## ST. JOHN'S CHURCH PROJECT FINAL EIR/ RESPONSE TO COMMENTS

State Clearinghouse Number: 2008032031

The City of Oakland  
May 2012

## NOTICE OF AVAILABILITY OF FINAL ENVIRONMENTAL IMPACT REPORT (EIR) TO COMMENT DOCUMENT FOR THE ST JOHN'S EPISCOPAL CHURCH IMPROVEMENTS

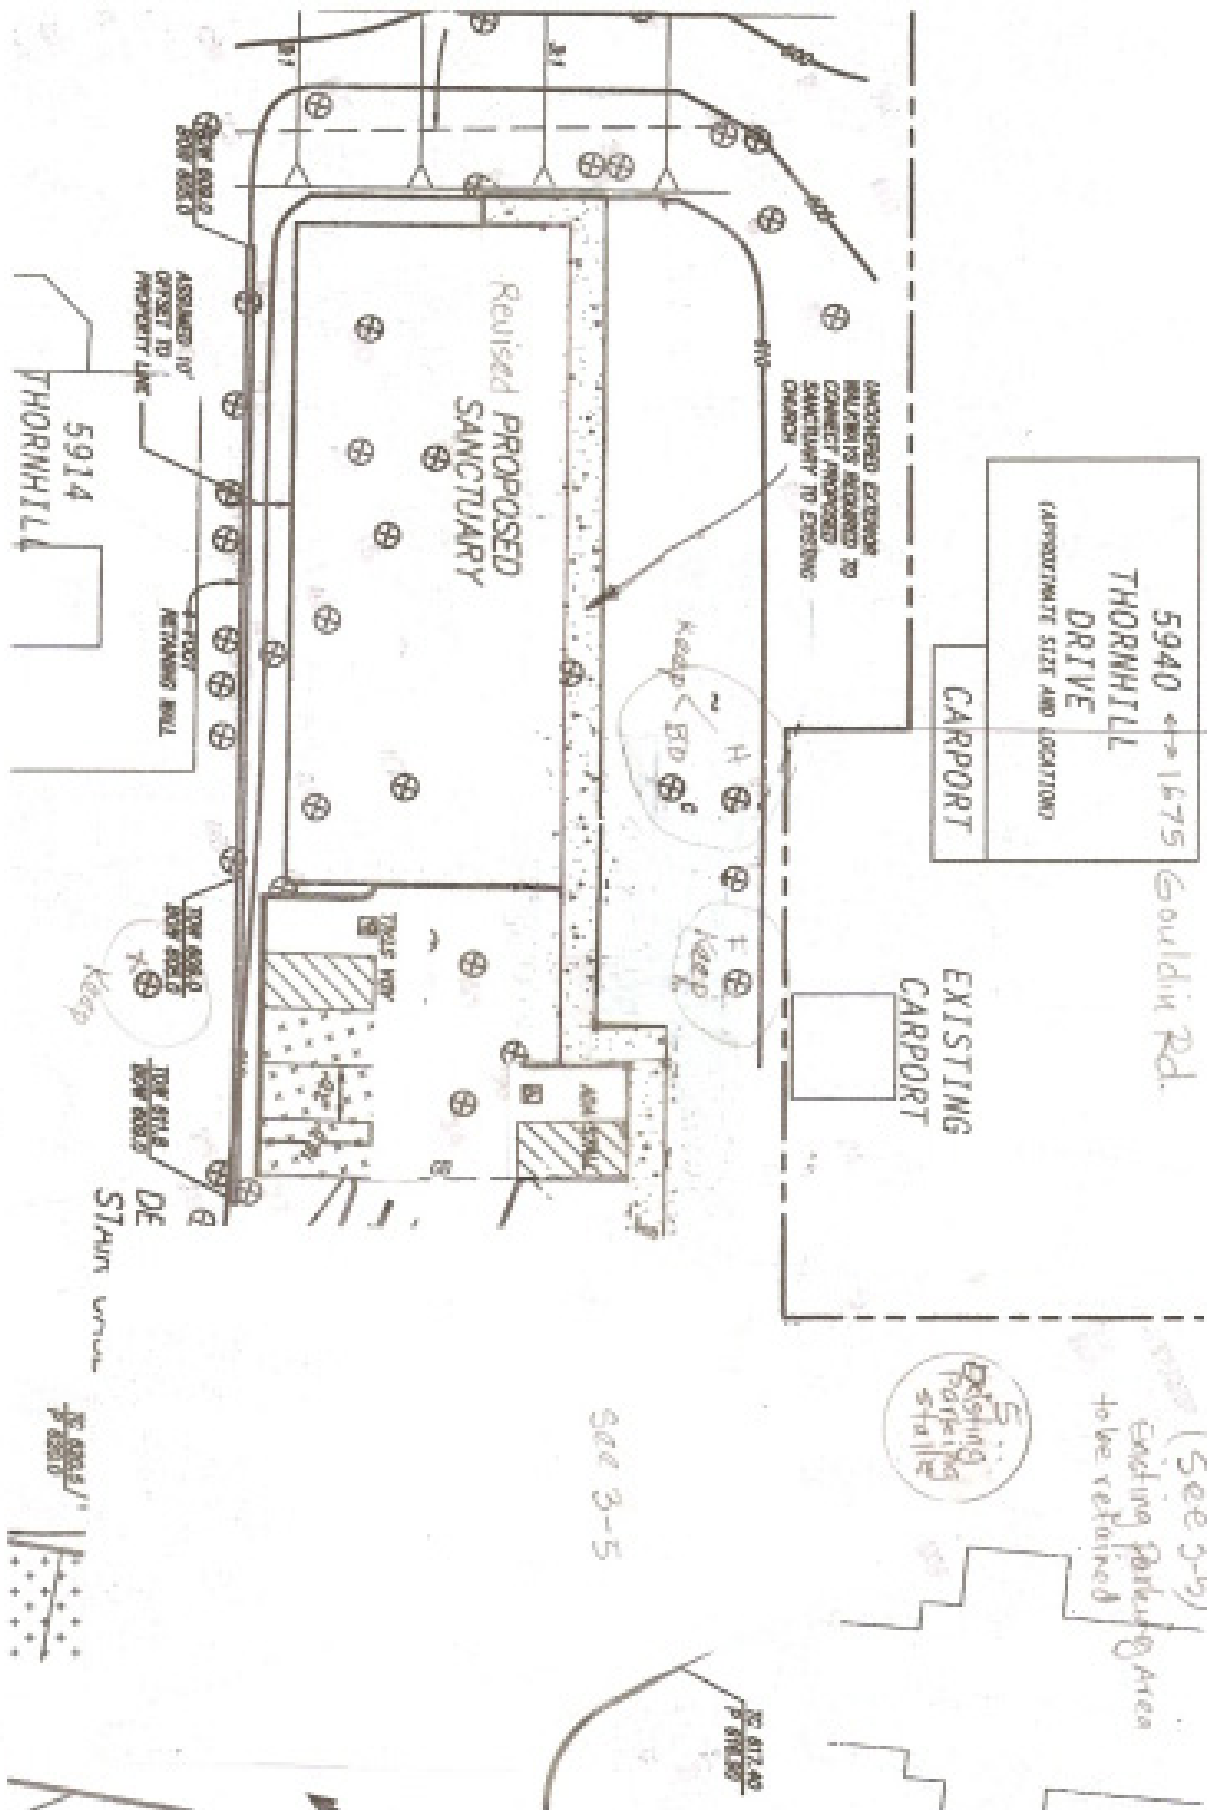
largest Redwoods, BD, H, and X (X is not mentioned on page 5-11, only the trees closest to me are. X is located at 1670 Alhambra Lane) with diameters of 36 inches, 61 inches, 56 inches respectively, and F, a Coast Live Oak with a diameter of 25 inches. Some of the parking spaces could be moved around to avoid the loss of these beautiful trees. (Please see my mark-up drawing B attached and refer to figures 5-1 and 5-5: Alternatives 2 and 3)

- C19-20. This comment provides a mark-up of Figure 3-5, Site Plan, presented on page 3-7 of Chapter 3, Project Description, of the DEIR. See Response to Comment C19-3.

- C19-21. This comment provides a mark-up of Figure 3-5, Site Plan, presented on page 3-7 of Chapter 3, Project Description, of the DEIR. See Response to Comment C19-3.
